General Property Information

13 John Sutton Place, Nelson

Created: 19 January 2026

SITE PLAN 1:100

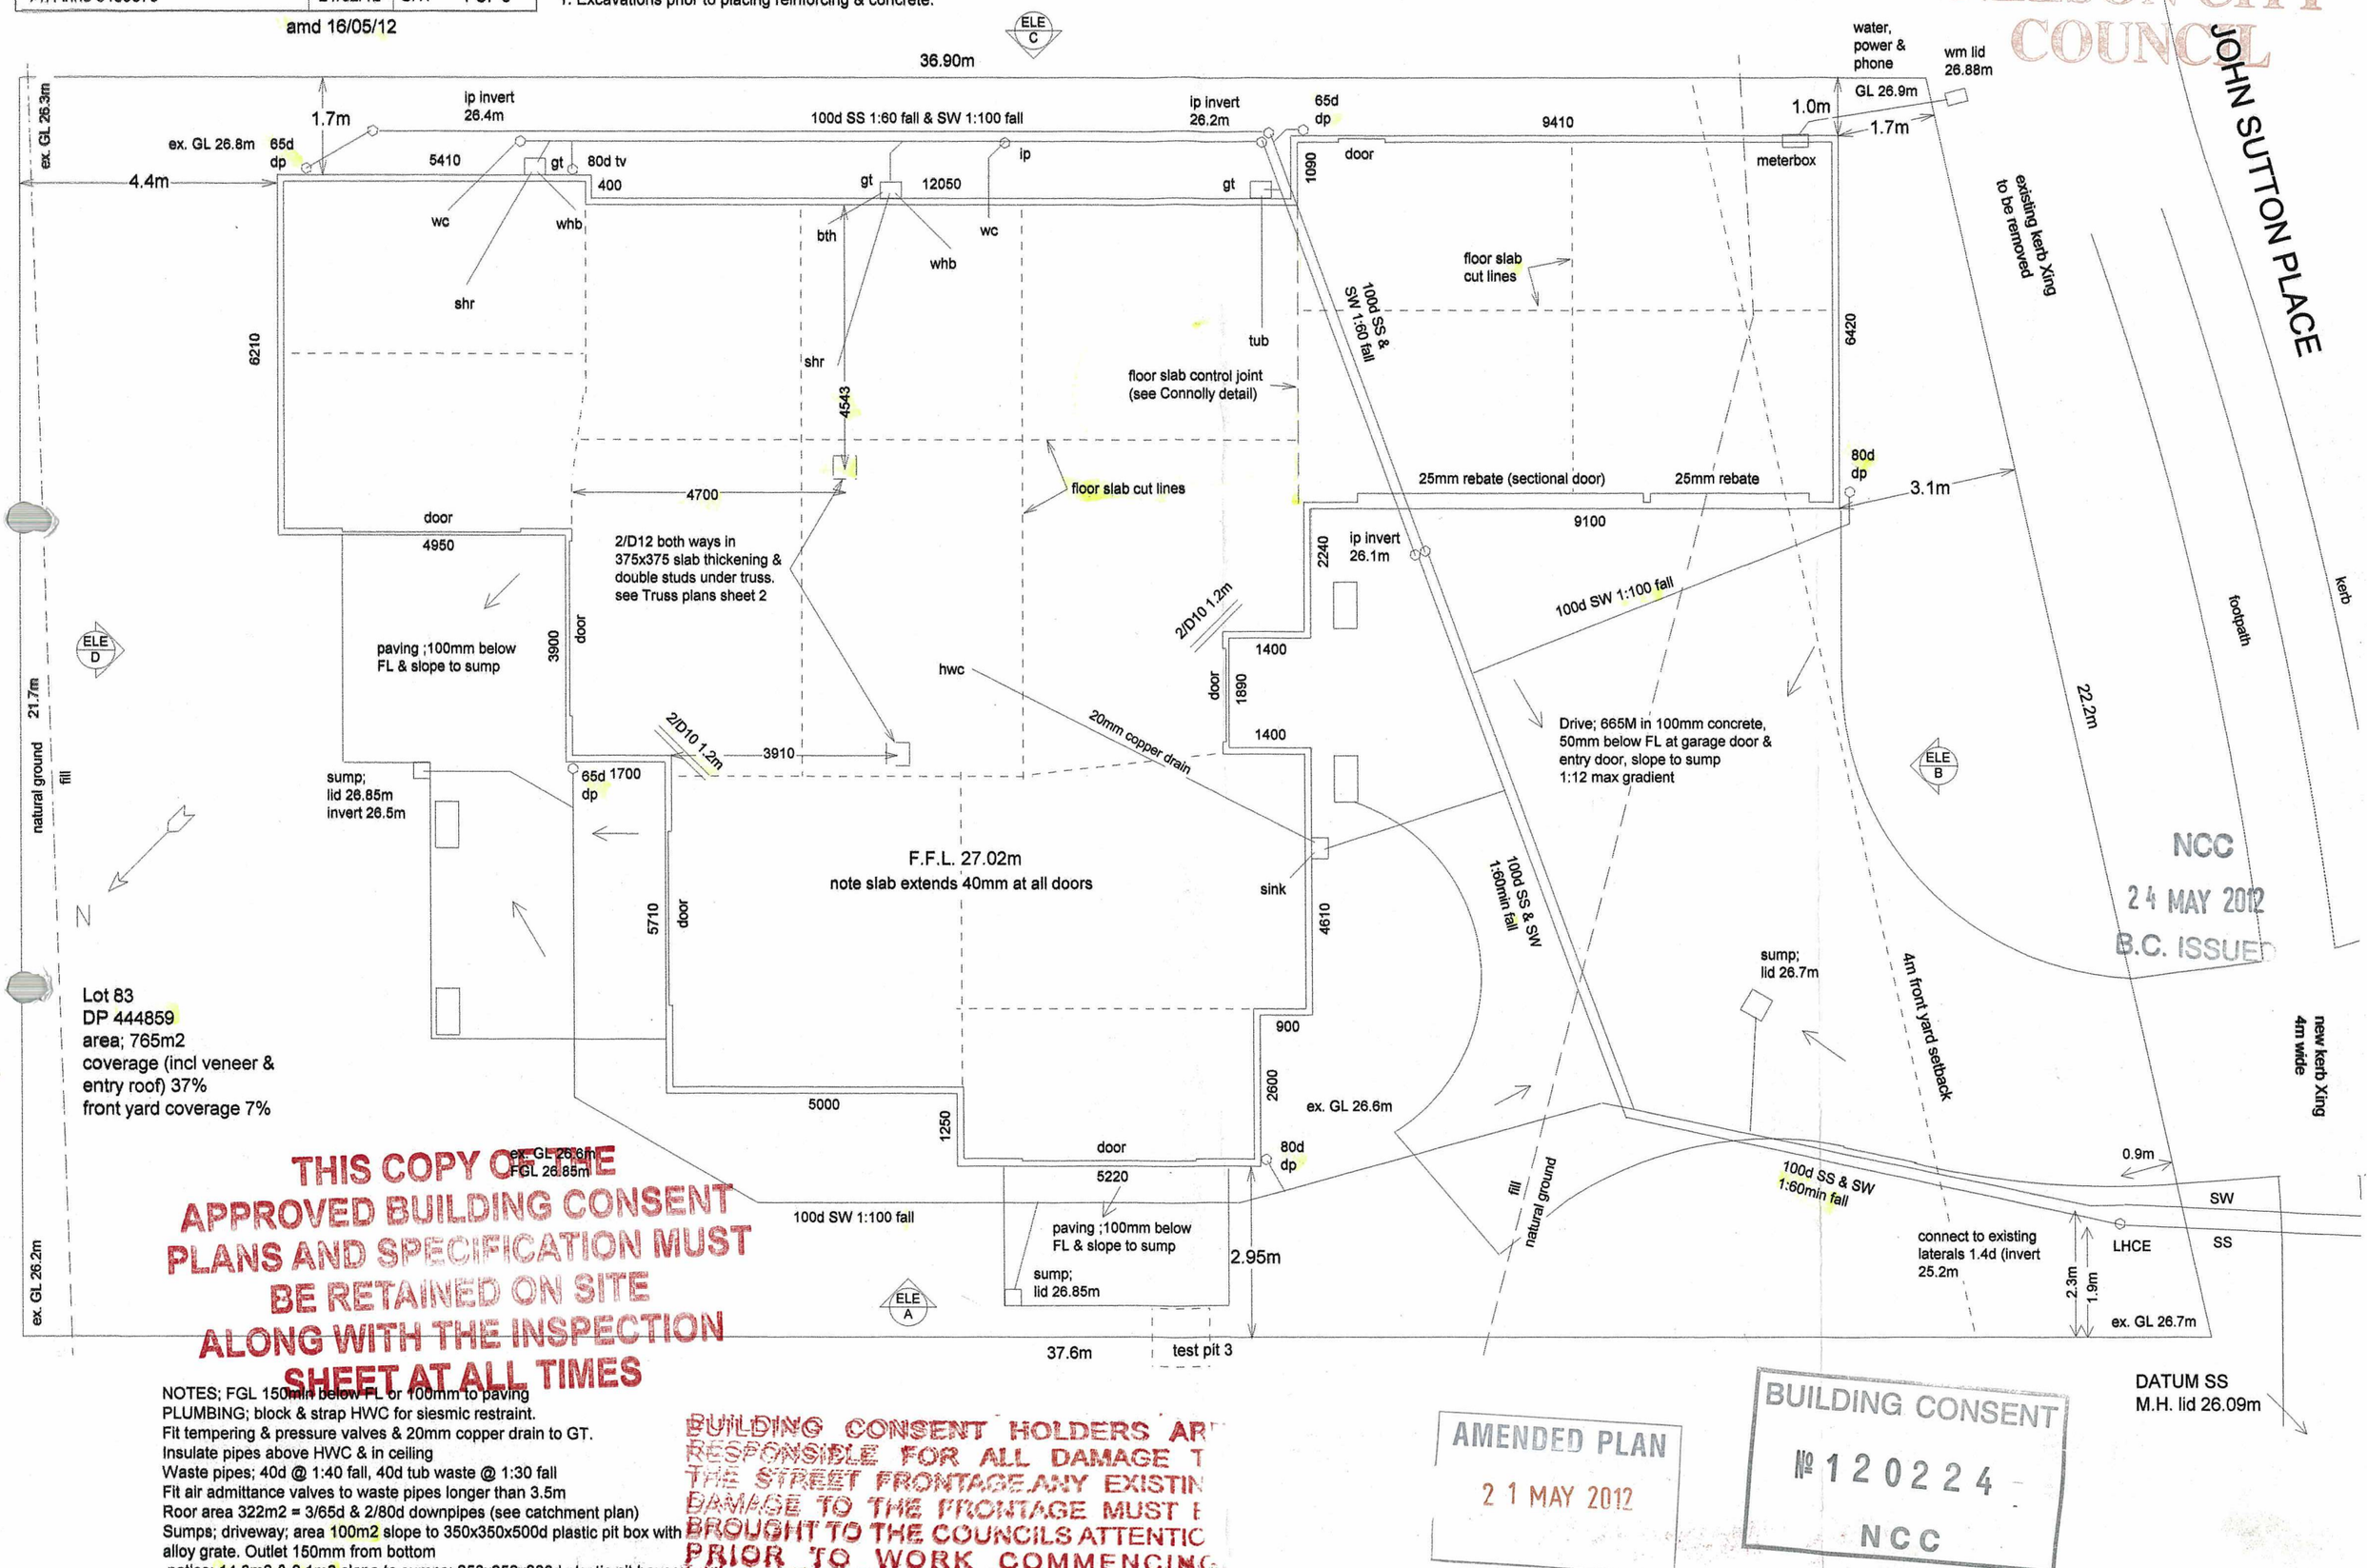
2. Please confirm whether a corridor access request has been lodged for the proposed kerb crossing shown on Sheet 1 of 5.

3. The wind zone specified on Sheet 1 of 5 is not in accordance with NZS 3604: 2011. I have determined the wind zone to be High (A, open, exposed, T1). Please amend all elements that are affected by this such as truss design, fixings, bracing calculations etc. or justify how compliance with NZBC Clauses B1.3.1-4 is achieved.

6. No free joint for the concrete slab is indicated on sheet 1 of 5. Also, the dimension of some bays exceeds 6m. Please amend these so compliance with NZBC Clauses B1.3.1-4 is shown. Also, please confirm whether the is supplementary reinforcing steel at the internal corner circled on plan (see attached plan) & whether the control joint is going through the 375x375 slab thickening (N.B. If the control joint is going the 375x375 slab thickening, please justify how compliance with NZBC Clauses B1.3.1-4 is achieved.)

Ph Anne 5459879	21/02/12	SHT 4 OF 5

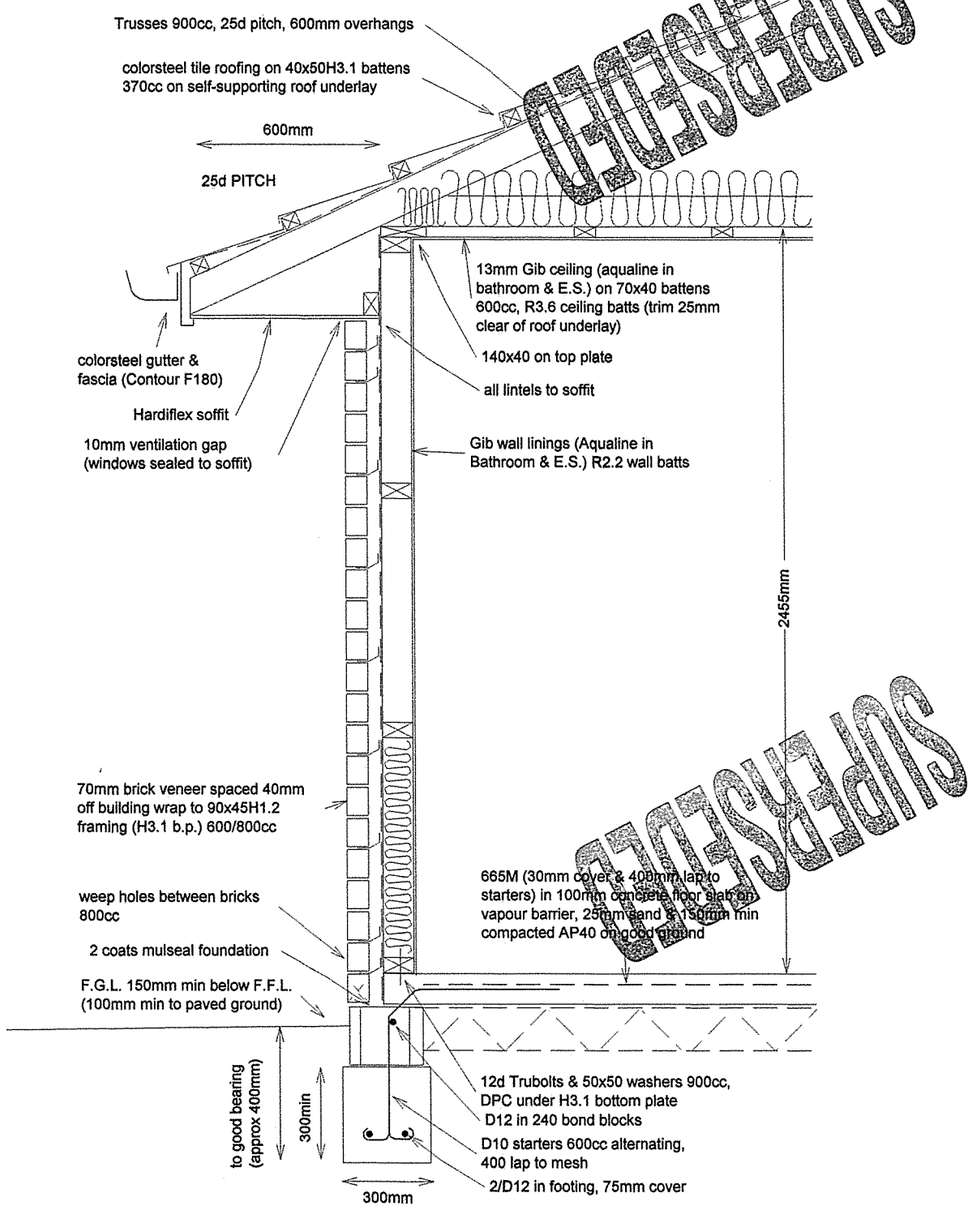
8. The spacing of the bottom plate fixing specified on sheet 4 of 5 exceeds the maximum spacing permitted by NZS 3604: 2011. Please modify or justify how compliance with NZBC Clauses B1.3.1-4 is established. Also, please specify the distance between the end of bottom plate & its fixing. For guidance please refer to clause 7.5.12.2 NZS 3604: 2011.

9. See amended PS1.
10. Note amended sheet 4 to include nail diameter.
11. The housing depth is amended to 15mm at top, 0mm at bottom. My thoughts regarding the fixings are; 4/100mm skew nails gives about 3kN fixing (6/100mm nails = 4.7kN; table 10.8) there is no roof on the pergola, the total timber area exposed to uplift is 3.2m2 or 1.6m2 on the stringer or 0.266m2 to each rafter end. If you use table 9.2, high wind, the stringer fixing required is about 2.4kN and for each rafter about 0.5kN. I prefer to use nails for this fixing rather than wire dogs or plates as this is a visible junction. The stringer is fixed with 3/M12 bolts which provides about 14.7kN fixing (2 bolts = 9.8kN). The soffit framing transfers any loading back to the wall framing with CPC80 fixings (5 x CPC80 = 40kN connection). The framing is also fixed to the truss (300mm overhang) which further prevents uplift. An identical structure (and house except mirror image) has been built at 1 Joyce place (by the same owner) about 1 year ago, perhaps you might like to compare the details from that file.

SECTION B-B
1:20

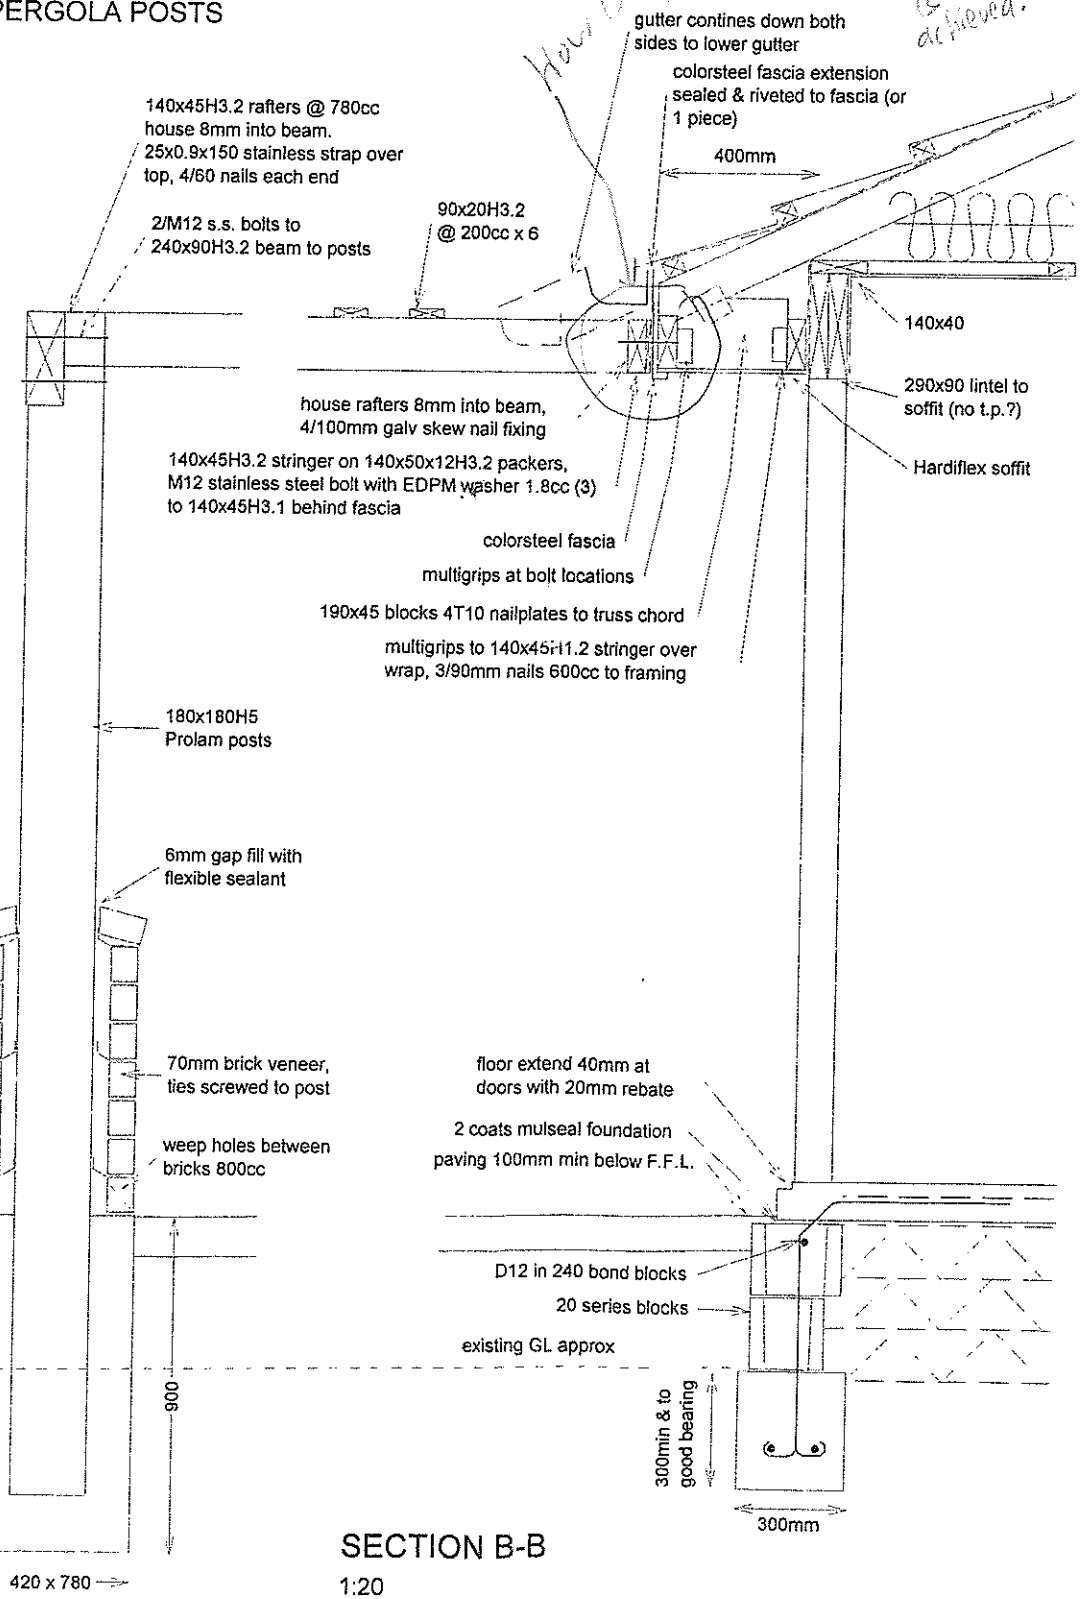
11. The depth of housing specified on section B-B does not comply with NZS 3604: 2011. Please revise or justify how compliance NZBC Clauses B1.3.1-4 is established. Also, please justify how compliance with NZBC Clauses B1.3.1-4 is achieved by the rafter fixings specified on section B-B & the multigrips shown on section B-B (see circled area on attached plan). For guidance please refer to Figure 10.5 & Table 10.1 NZS 3604: 2011.
